RISK AREAS FOR DEVELOPMENT DUE TO UNDERMINING CONSTRAINTS THREE SISTERS RESORTS

TO: The Mayor and Town Council of Canmore
RE: Three Sister's Resorts Proposed Development

Factor of Safety as it Relates to Hazards associated with Canmore's Friable Coal

SURFACE MINING FEATURES
 RUNDLEVIEW ESTATES PHASE

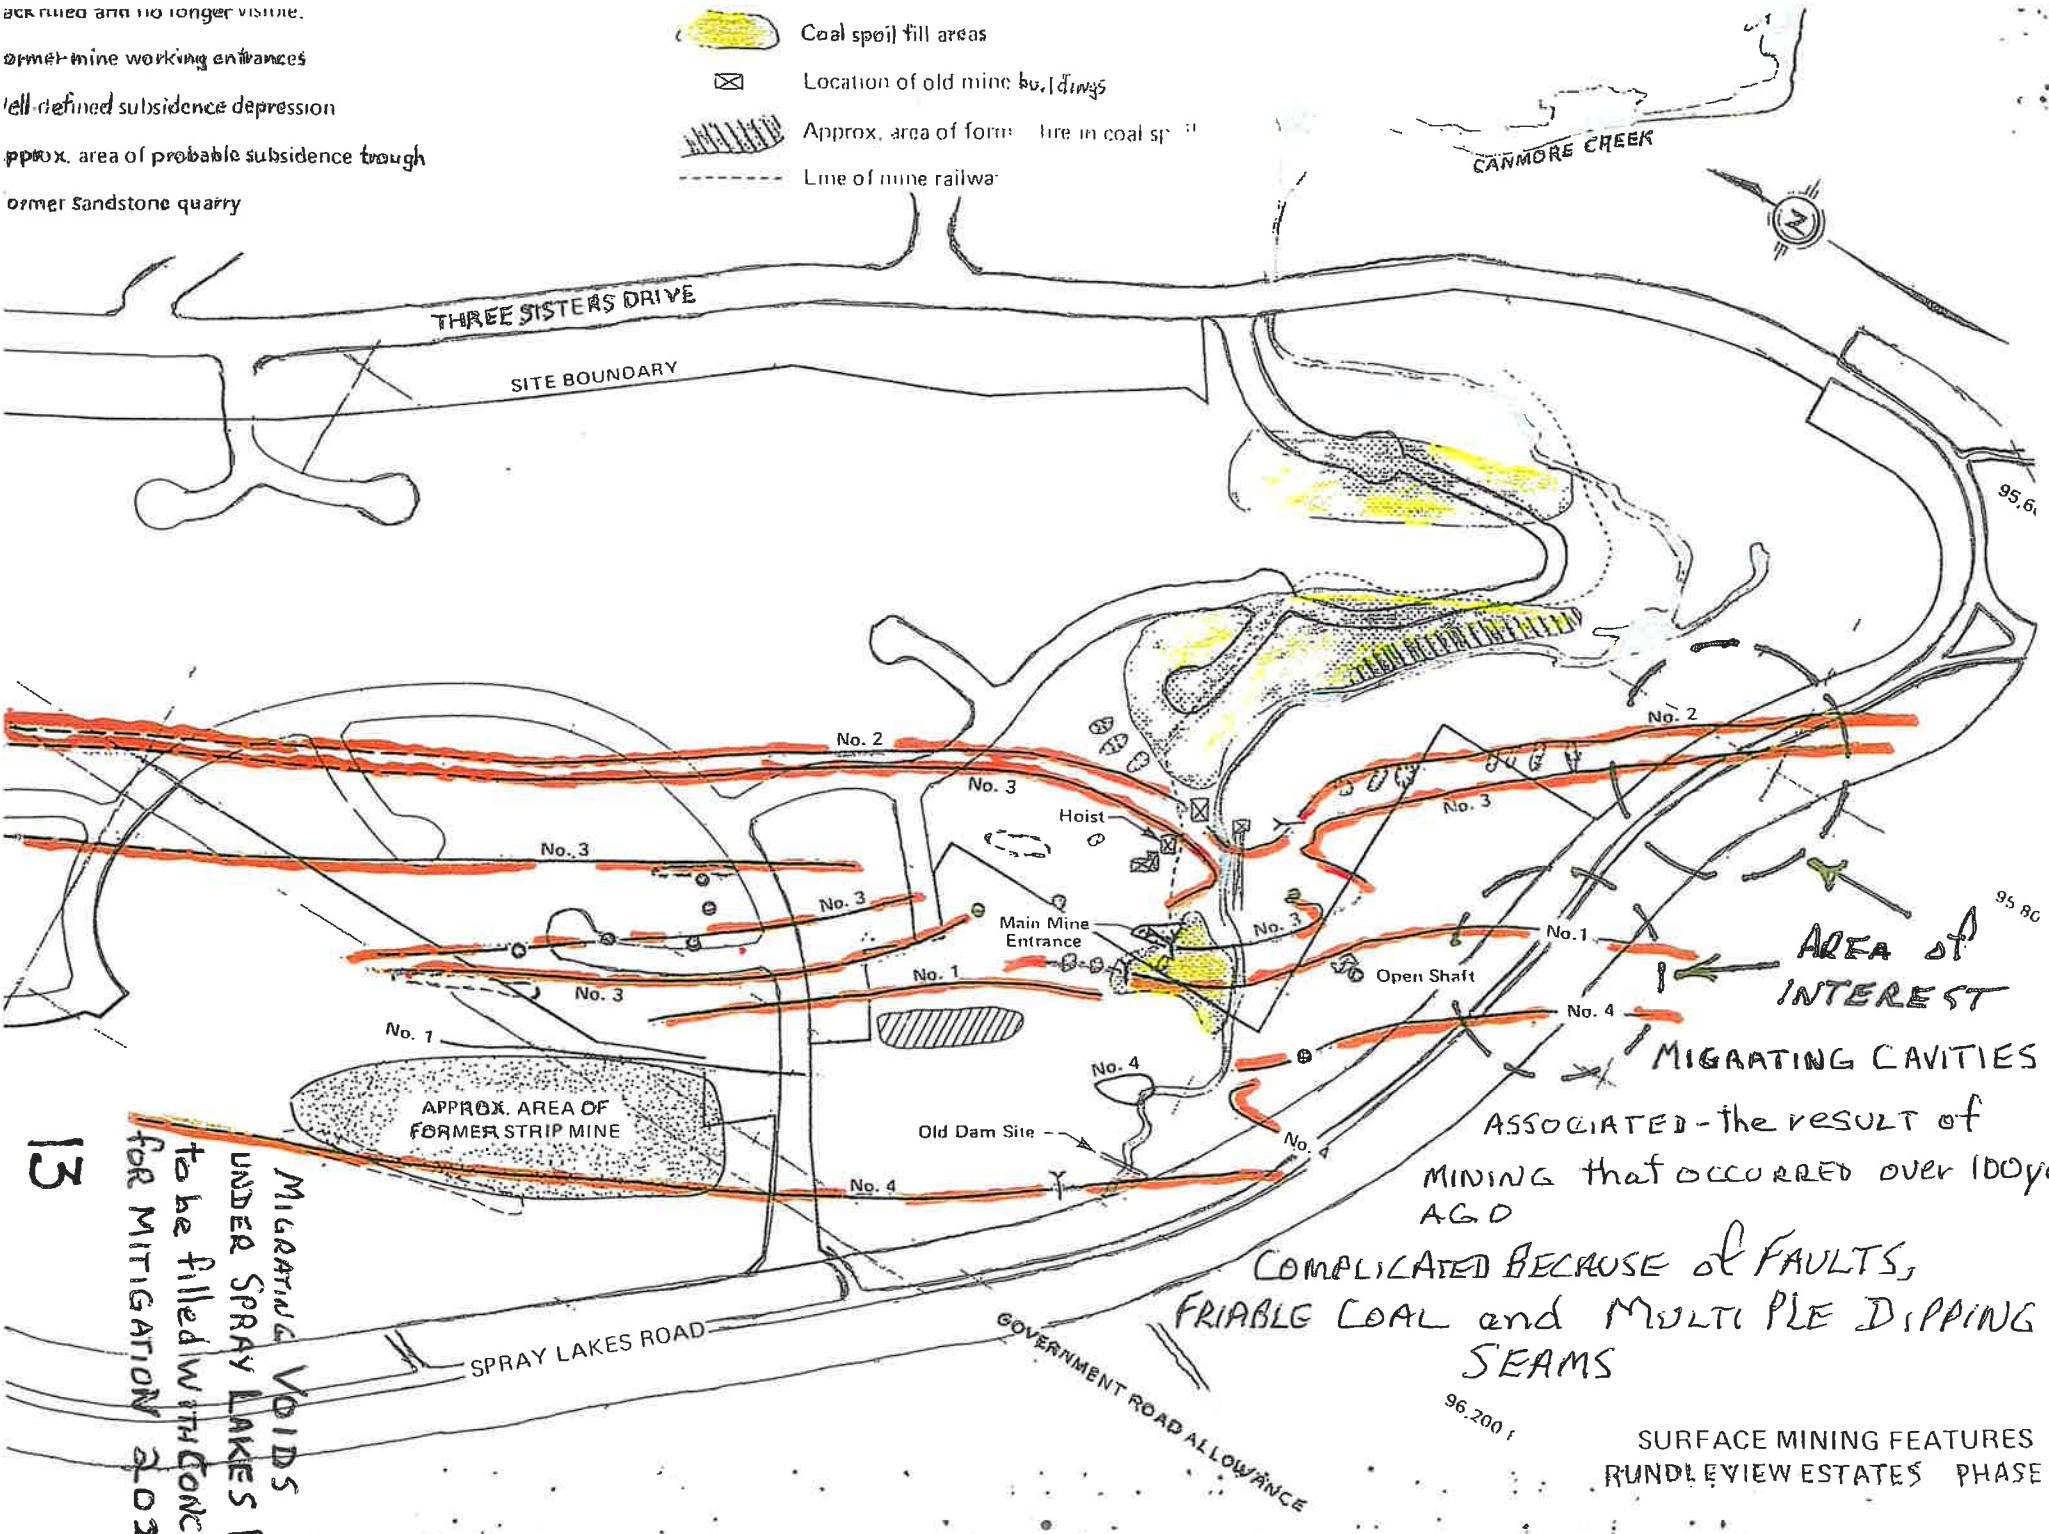
AREA OF INTEREST
 MIGRATING CAVITIES
 ASSOCIATED - the result of MINING that OCCURRED over 100yrs AGO

COMPLICATED BECAUSE OF FAULTS,
 FRIABLE COAL and MULTIPLE DIPPING SEAMS

13
 MIGRATING VOIDS
 UNDER SPRAY LAKES Rd.
 to be filled with CONCRETE
 for MITIGATION 2021
